REPORT TO PLANNING COMMISSION

Hearing Date: June 11, 2012
File Number: 2012-7012

SUBJECT: **Steve Hoffman (Appellant) / 162 N Wolfe LLC (Applicant/ Owner)**: Application for a 0.36-acre site located at **162 North Wolfe Road** in an M-S Zoning District (APN: 205-43-027):

Motion **2012-7012 –** Appeal of a decision by the Director of Community Development approving a Miscellaneous Plan Permit for parking lot restriping and minor landscaping modifications.

SHEET A-1-45

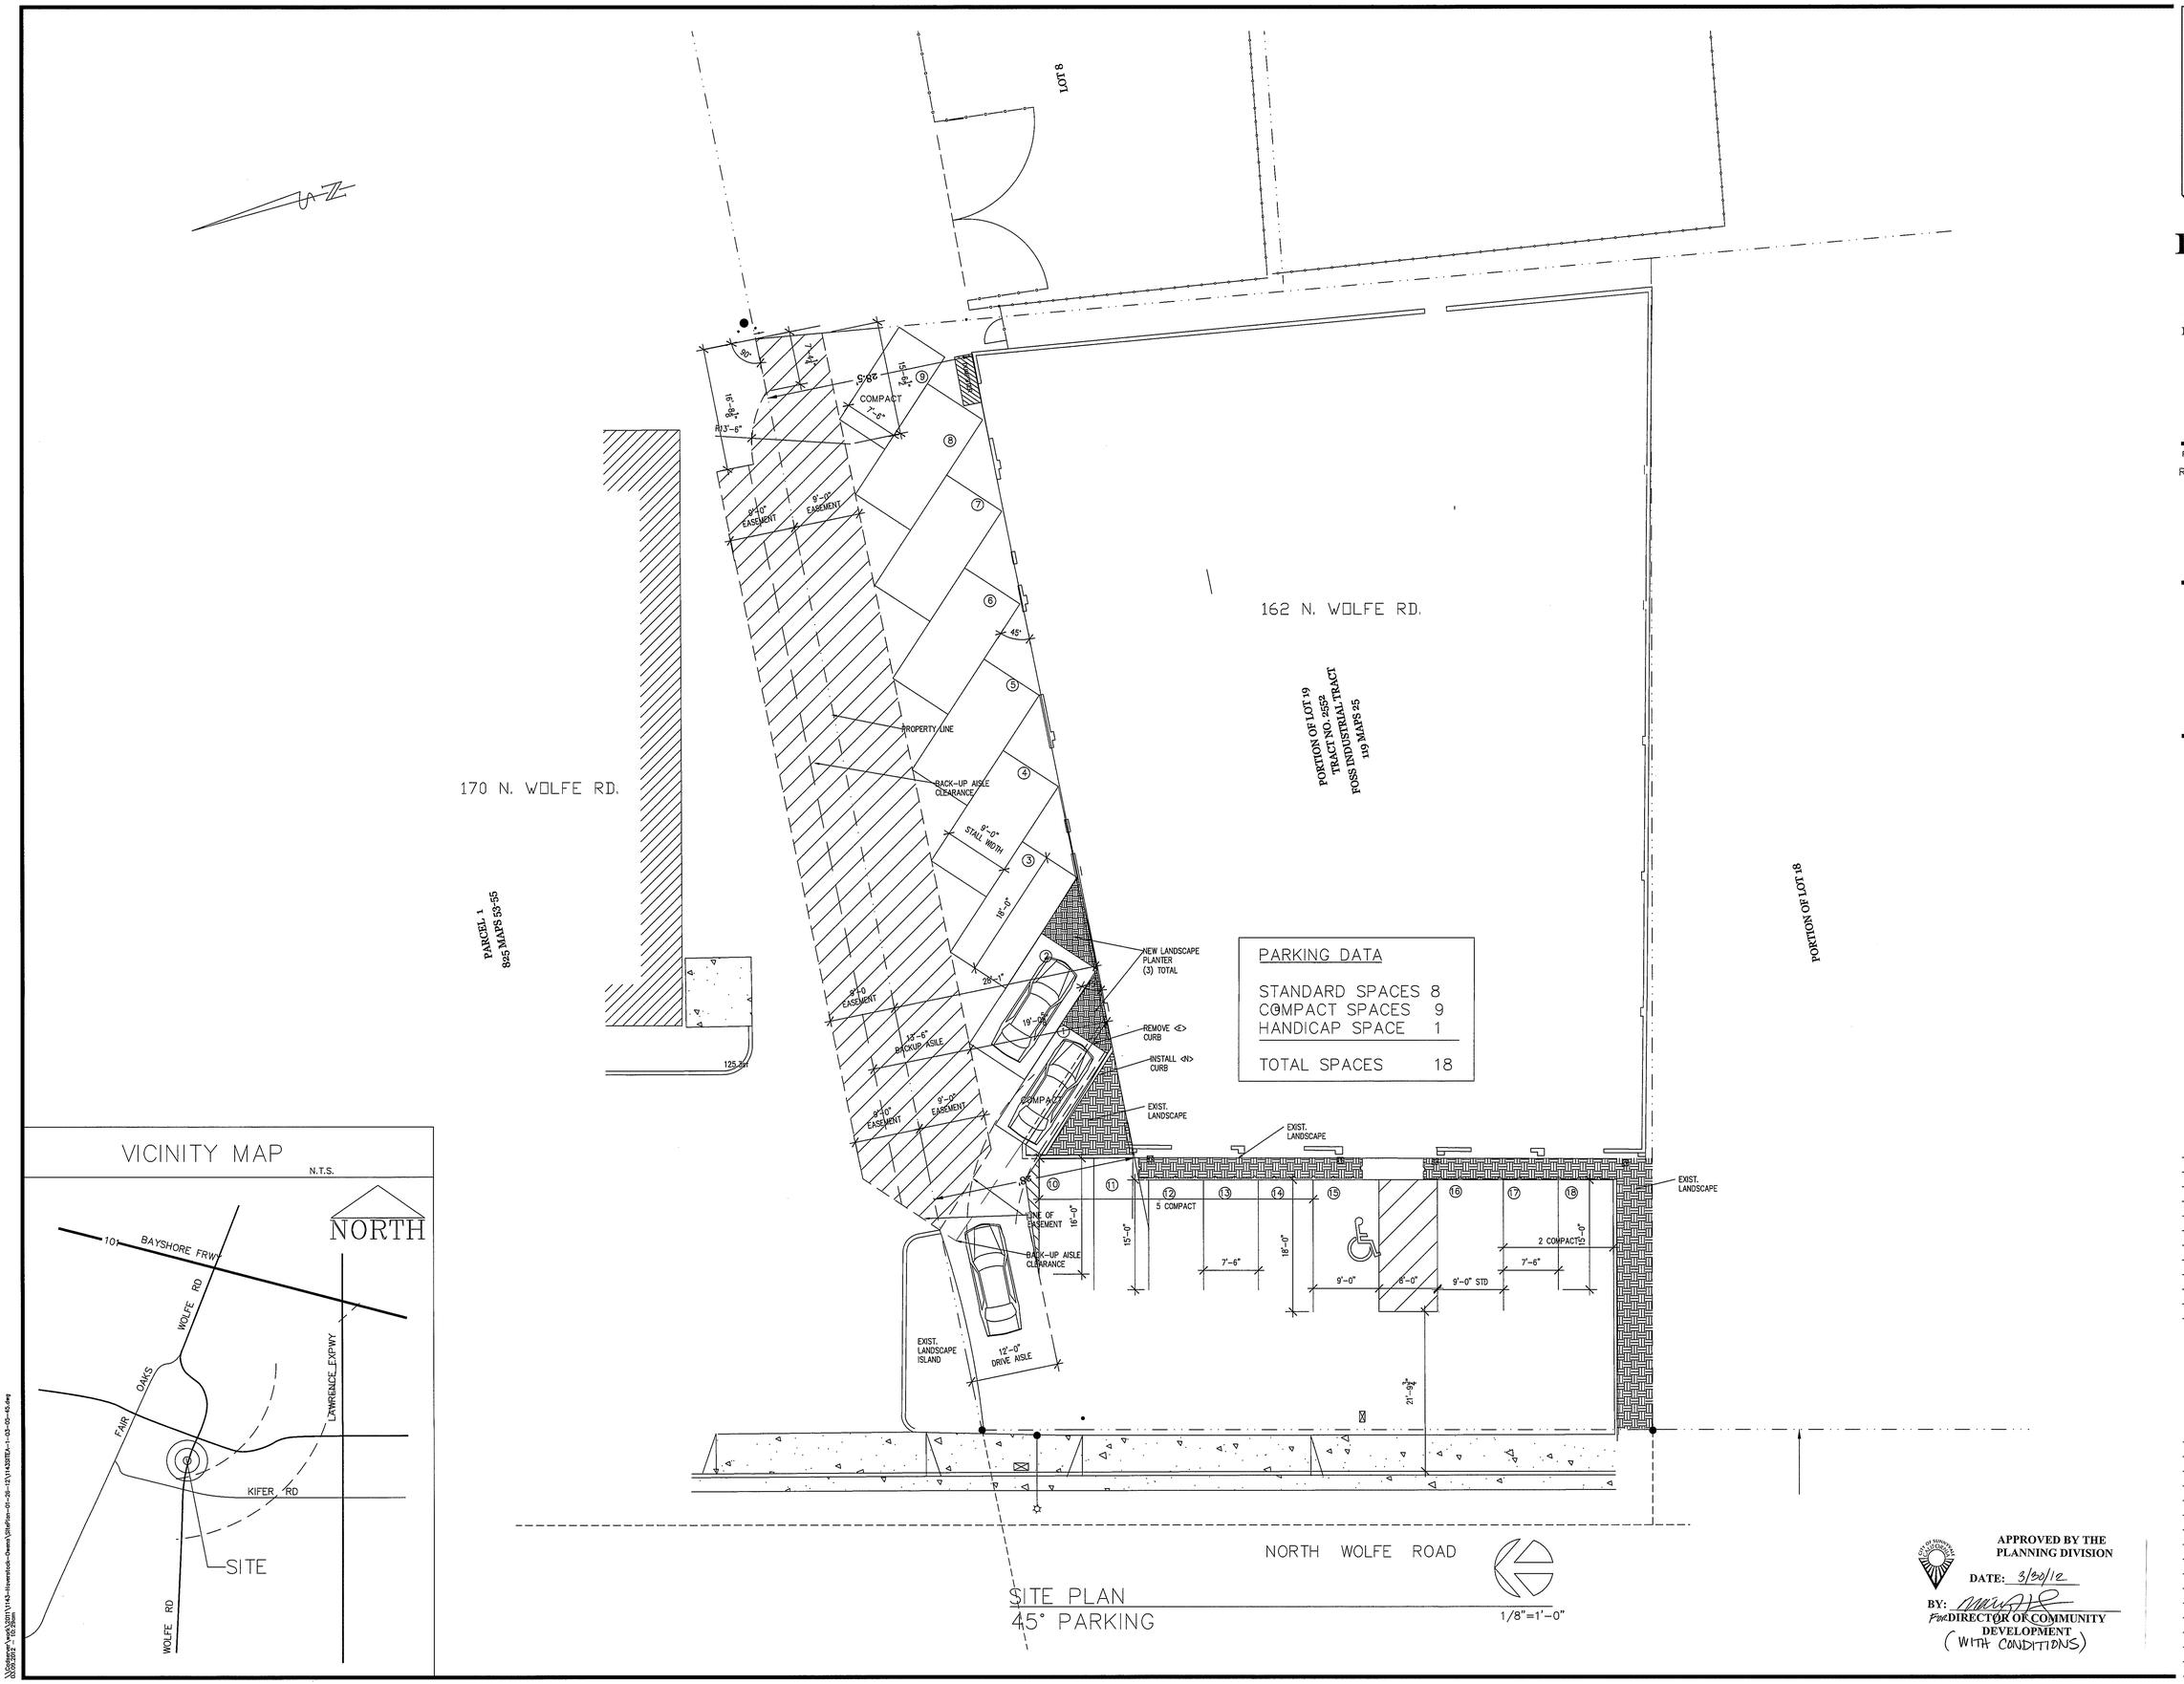
1. The NEW parking plan submitted to the City on behalf of the ownership of the property at 162 N. Wolfe Road does not provide circulation for vehicular traffic. The plan depicts a one-way aisle for vehicles to enter into the 45 degrees parking spaces on the north side of the property, but no exit path is provided.

The maximum available width of the passage way north of the 162 N. Wolfe Road property (including a future 9 foot wide easement over the neighboring 170 N. Wolfe property is only 18 feet. This is not sufficient for a two way driveway as SMC 19.46.130 calls for a minimum of 20 feet. Furthermore, there is no adequate turn around area as is required by SMC 19.46.130. As such, the new parking plan submitted by the ownership of the 162 N. Wolfe Road property is in violation of SMC 19.46.130.

2. SMC 19.46.100 (copy attached) states the minimum aisle width required for entry and exit of diagonal parking. The diagonal parking in the subject property's new parking plan is 45 degrees assuming traffic is traveling from west to east (eastbound). However, if vehicles are allowed to exit or enter these parking spaces when traveling from east to west (westbound), then the effective angle of entry and exit into these parking spaces is 135 degrees. SMC 19.46.100 does not state the minimum aisle width for 135 degrees, however, if it did it obviously would be much greater that what the code specifies for 90 degrees which is 26 feet.

As mentioned above, the maximum available width of the passage way north of the 162 N. Wolfe Road property (including a future 9 foot wide easement over the 170 N. Wolfe property), is only 18 feet which is far less than the 26 feet required for 90 degrees and certainly less than what would be required if the code even specified an aisle width for 135 degree parking. As such, the new parking plan submitted by the ownership of the 162 N. Wolfe Road property is in violation of SMC 19.46.100.

3. SMC 19.46.150 (copy attached) states that every building shall provide and permanently maintain for loading purposes a minimum of one off-street loading space. In violation of this code, the new parking plan submitted by the ownership of the 162 N. Wolfe Road does not specify any such area.

4. SMC 19.46.150 further specifies that every building which is required to provide fifteen or more parking spaces, as is the case for the 162 N. Wolfe Road property*, shall also provide and permanently maintain for loading purposes a minimum of one off-street loading space within ten feet of the use or building served. In violation of this code, the new parking plan submitted by the ownership of the 162 N. Wolfe Road does not specify any such area.

Staff response: As noted above, this aspect of site circulation is an existing legal nonconforming condition. The proposed plan maintains this legal nonconforming condition, and in fact decreases the level of nonconformity by locating fewer parking spaces to the north of the building and replacing at least one previously unusable space with a more functional layout.

Staff response: The Code section in question refers to driveways, not drive aisles. The appellant appears to be confusing these terms. The parking spaces on the subject site are served by aisles, so this section of the Code is not

applicable. Nevertheless, the subject site is served by a two-way driveway along Wolfe Road with a width exceeding the 20-foot minimum.

Staff response: The subject site is served by a two-way driveway along Wolfe Road meeting current requirements for driveway width. While the site layout provides minimal opportunities for vehicle turn-around, the lack of turning space results from the site's existing legal nonconforming conditions. The proposed project does not increase the level of nonconformity; in fact, the project as conditioned is expected to improve site circulation in several ways.

Staff response: The Sunnyvale Municipal Code does not provide standards for parking spaces with an angle greater than 90 degrees; it is assumed spaces would be entered from a direction resulting in an angle of 90 degrees or less. The proposed parking lot layout does not necessitate or encourage entering the angled parking spaces from the east. The Parking Management Plan (see draft in Attachment D) instructs employees to enter the angled parking spaces from the west and to avoid crossing outside the easement area. But even if a vehicle entered these spaces from the east, it could back into the angled spaces to avoid making such a wide turn. The appellant's assumption that vehicles may attempt to enter these spaces from the east does not change the City's determination as to the parking angle, nor result in an increased aisle width requirement. The proposed project with the easement area depicted on the plans complies with Code requirements for stall depth and back-up distance for 45-degree angled parking.

Staff response: The appellant appears to be referring to the first sentence in SMC 19.46.150(a) which states, "Every industrial, institutional, warehouse, or wholesale use or building shall provide and permanently maintain for loading purposes only a minimum of one off-street loading space." Staff notes a loading space is not required for all buildings as stated by the appellant; only those types specifically referenced in the Code. The subject site is occupied by an office use which is not required to provide an off-street loading space. But if the site were subject to this Code requirement, the lack of a loading space would be a legal nonconforming condition.

Staff response: The appellant appears to be referring to the second sentence in SMC 19.46.150(a) which states, "Every commercial use or building which is required to provide fifteen or more parking spaces shall also provide and permanently maintain for loading purposes only a minimum of one off-street loading space within ten feet of the use or building being served." It is not City practice to classify offices as "commercial" uses for the purpose of the loading requirement. As a result, loading spaces are typically not required for office buildings. The loading requirement for commercial buildings/uses is typically applied to shopping centers, retail uses, and restaurants. If the site were subject to this Code requirement, the lack of a loading space would be a legal nonconforming condition as noted in #3 above.

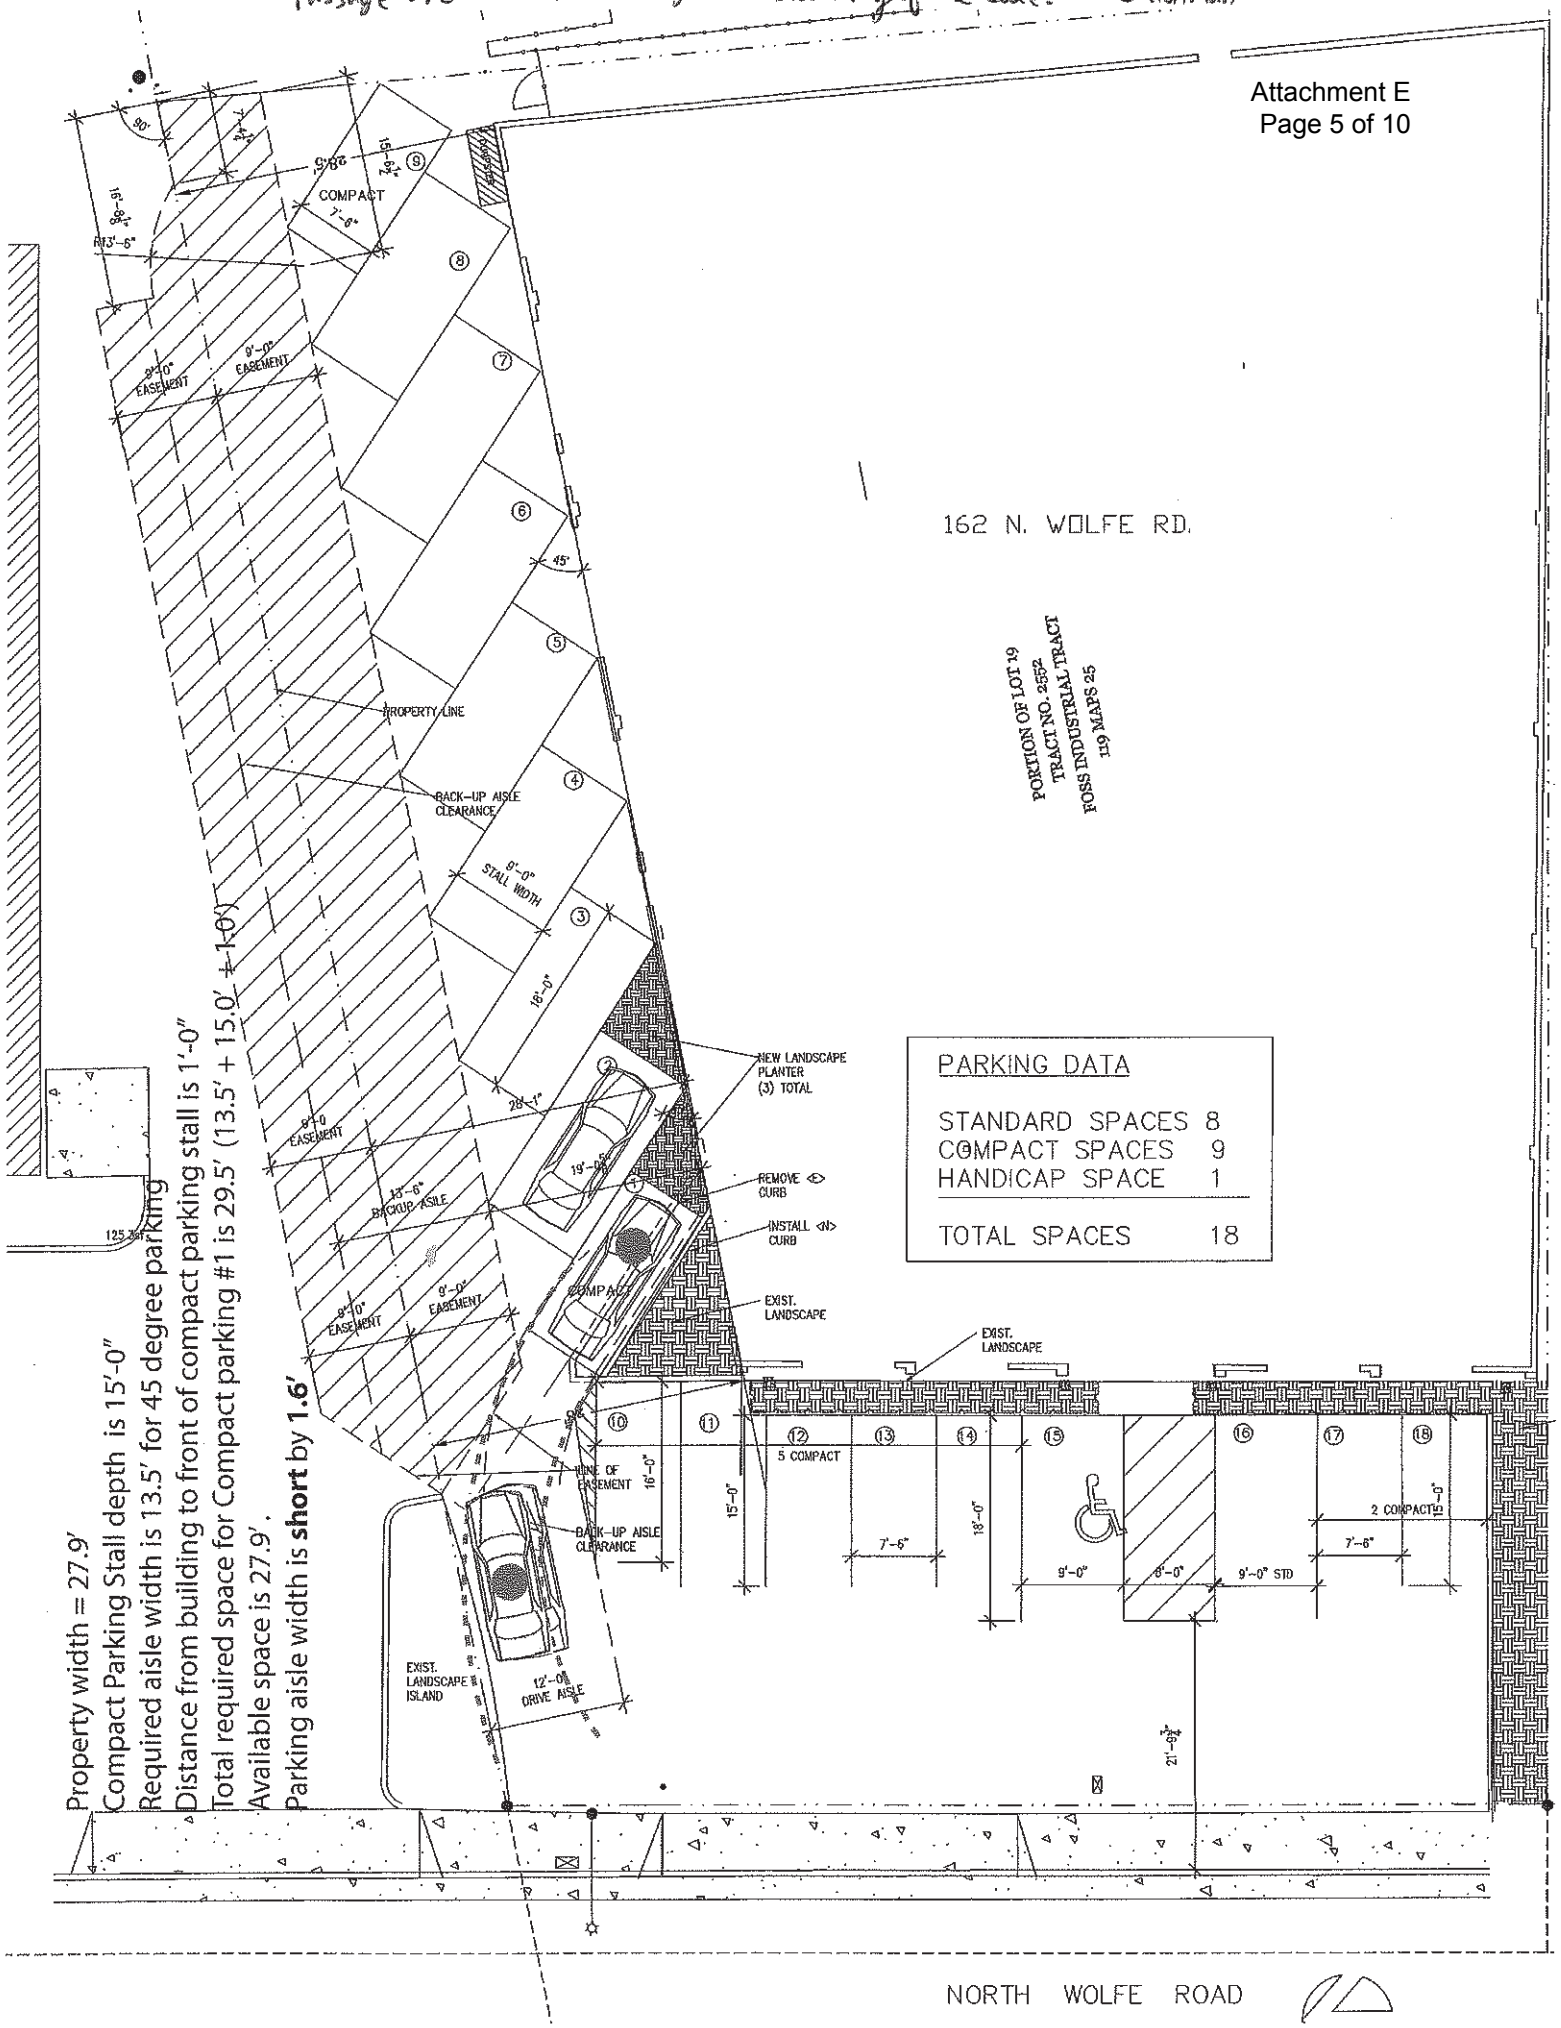
Passage arc is based on my understanding of the code. Steve Hoffman

Property width = 27.9'
Compact Parking Stall depth is 15'-0"
Required aisle width is 13.5' for 45 degree parking
Distance from building to front of compact parking stall is 1'-0"
Total required space for Compact parking #1 is 29.5' (13.5' + 15.0' + 1'-0")
Available space is 27.9'.
Parking aisle width is **short** by **1.6'**

Staff response: The appellant provides six diagrams depicting a vehicle turning into the angled parking spaces along the north side of the building. These diagrams appear to indicate that a vehicle cannot enter the angled spaces without driving over an existing landscaping area or crossing outside the easement area. The turning radius shown in these diagrams does not match accepted turning templates used by the City's Transportation and Traffic Division. The first four diagrams suggest a vehicle must swing widely to the left before turning into the angled parking spaces. Transportation and Traffic staff has reviewed the diagrams and confirmed the wide arc shown on these plans would not be necessary for a passenger car or truck. The required drive aisle width of 12 feet would be sufficient to allow vehicles to enter the spaces, and the required back-up distance of 13.5 feet would be sufficient to allow vehicles to reverse out of the spaces. Additional maneuvering area should not be needed. The fifth and sixth diagrams depict a vehicle entering the angled parking spaces from the east. As noted in #2 above, vehicles entering from the east could back into the parking spaces. In addition, implementation of the Parking Management Plan will address concerns about these vehicular movements.
